AGENDA
REGULAR MEETING OF THE BIRMINGHAM PLANNING BOARD
WEDNESDAY SEPTEMBER 28, 2022 – 7:30 PM
151 MARTIN ST., CITY COMMISSION ROOM 205, BIRMINGHAM MI*

SUBJECT: 295 Elm St. – Forest Townhomes – Final Site Plan & Design Review

RE: Final Site Plan Review Comments
469-479 S. Old Woodward, Revised Site Plan

SD.1

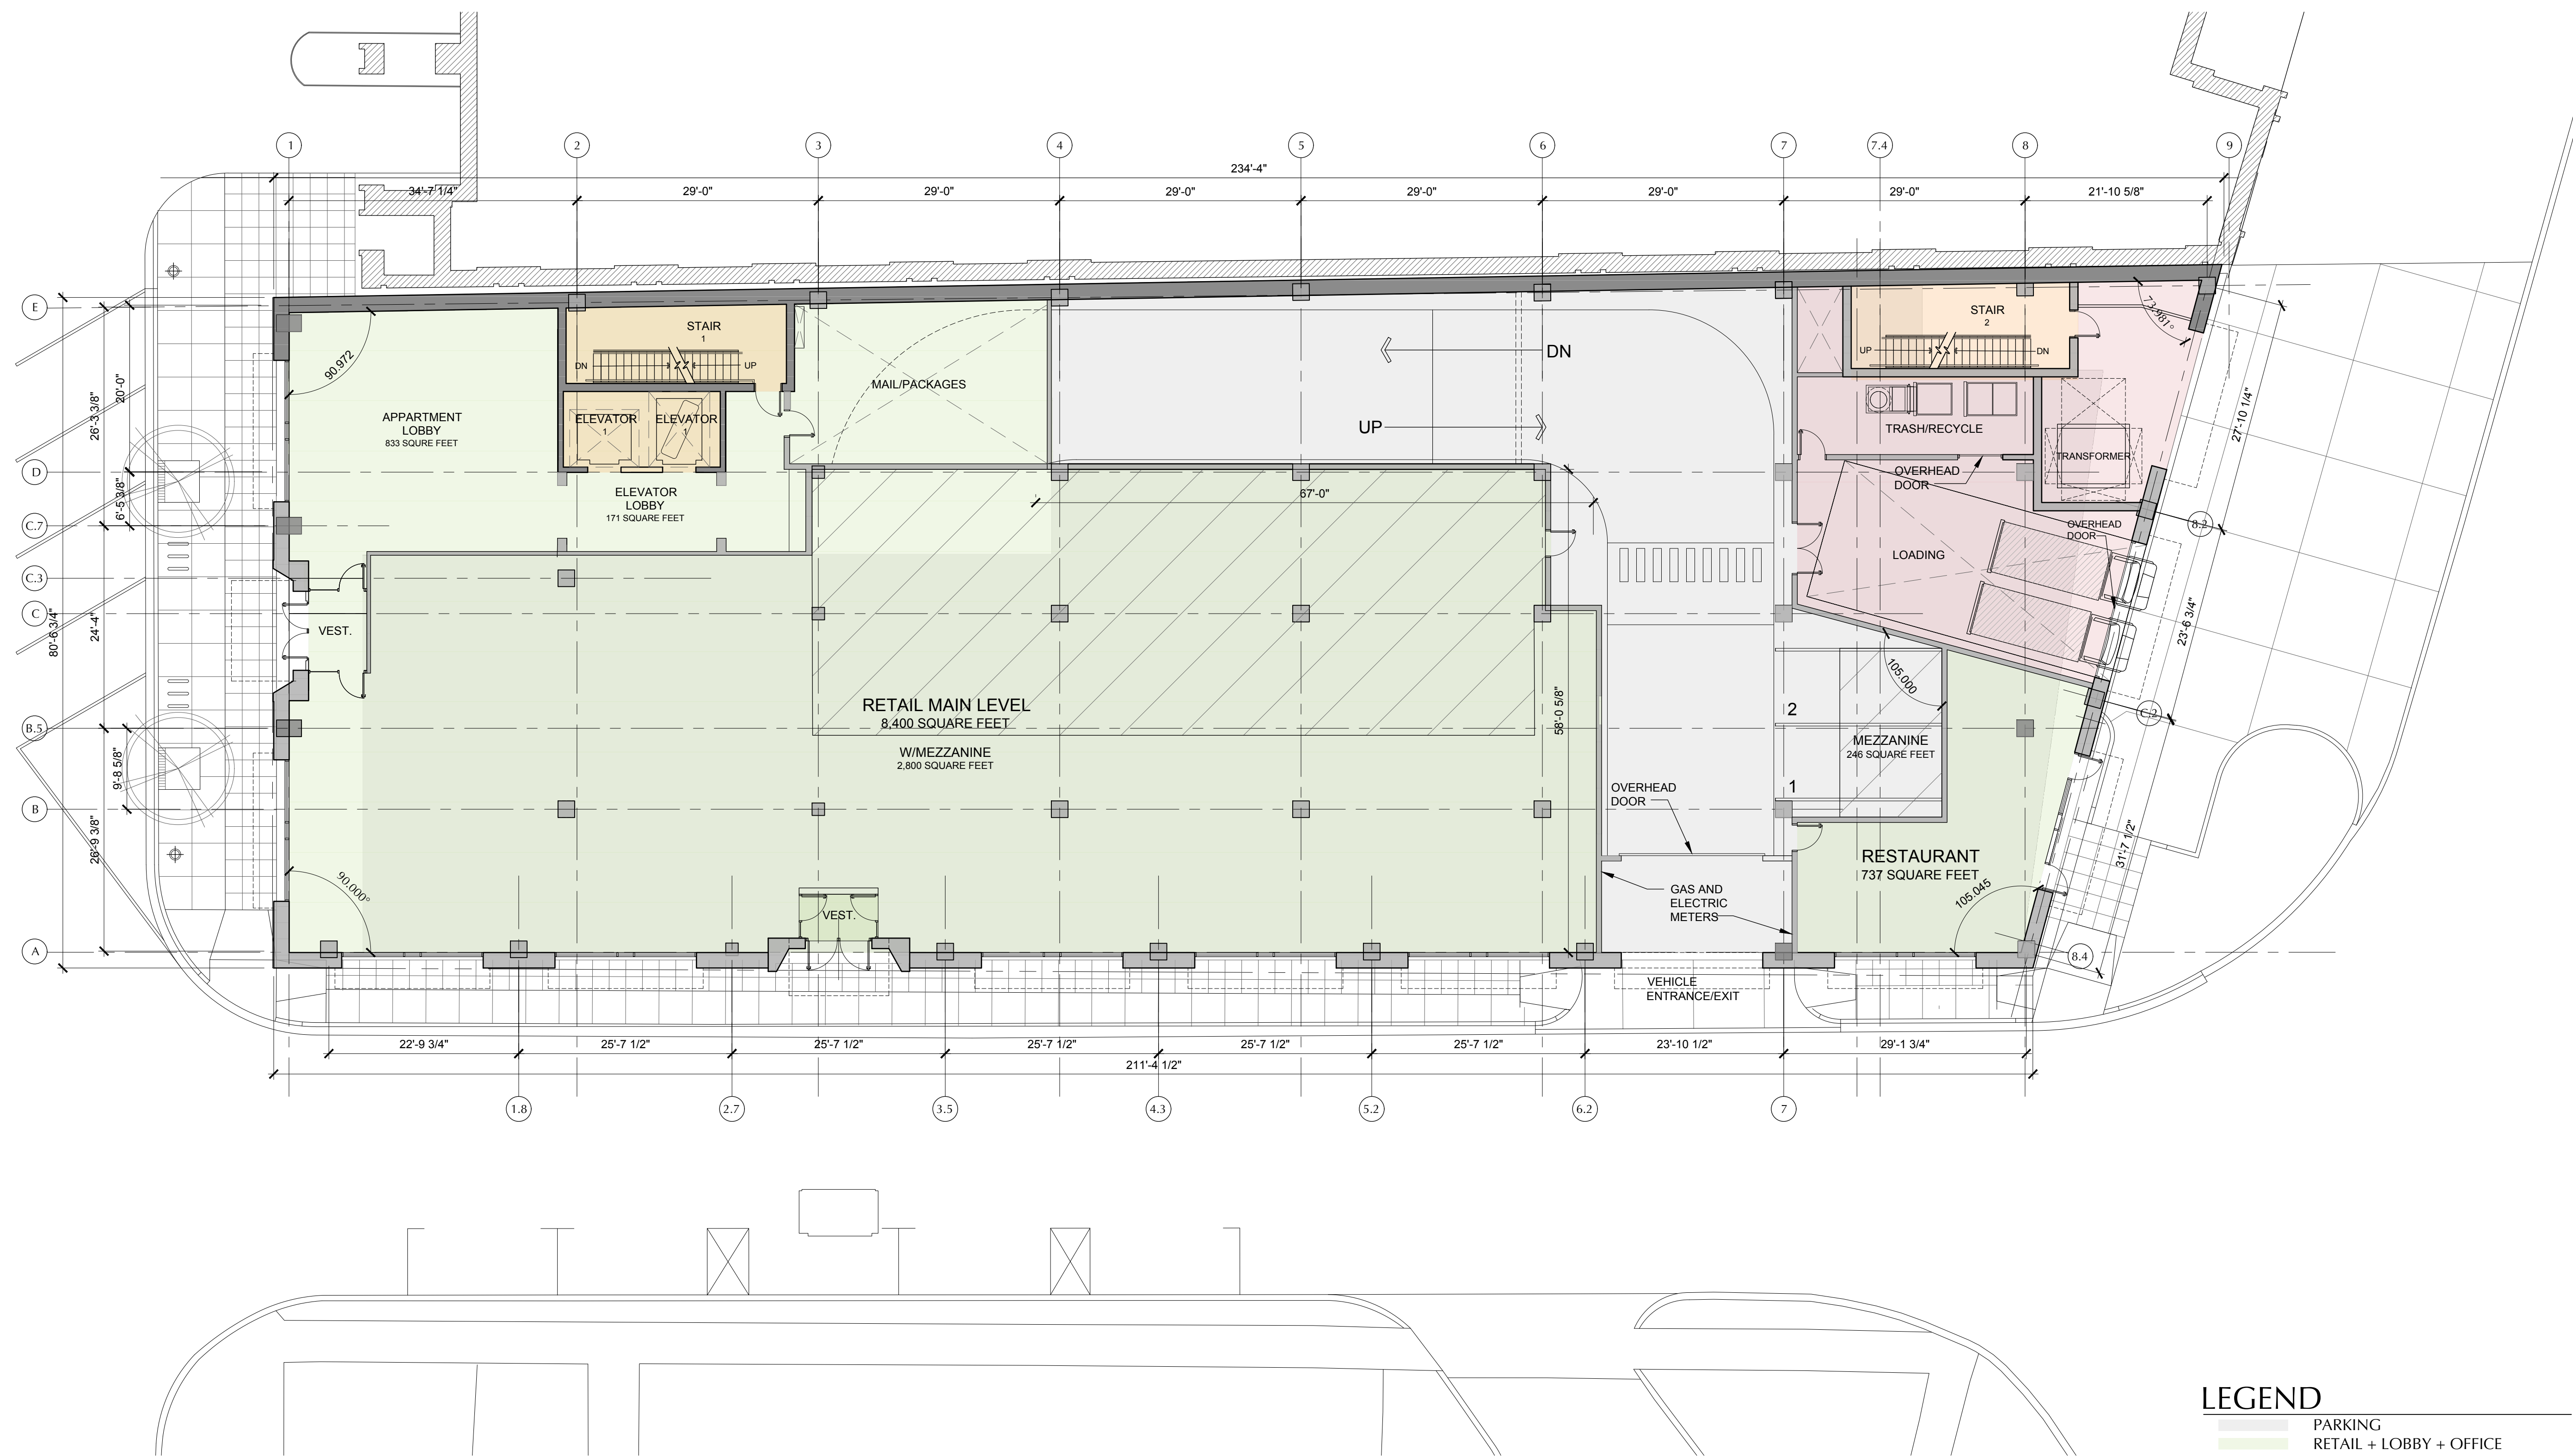
Sheet SD.1 indicates the proposed mezzanine space in hash marks. The retail mezzanine is proposed to be 2,800 sq. ft. which is one third of the 8,400 sq. ft. retail room it is within. The restaurant mezzanine is proposed to be 246 sq. ft. which is one third of the 737 sq. ft. restaurant room it is proposed to be within. Mezzanines do not count as an additional floor as long as they are less than one third of the room in which they are in, however the floor area of a mezzanine is included in the parking requirement calculations.

The Planning Division requires that a more detailed floor plan for the mezzanine be provided with the site plan, and that sheet SD.1, SD.3 and all other floor plans be submitted with an architectural certification.
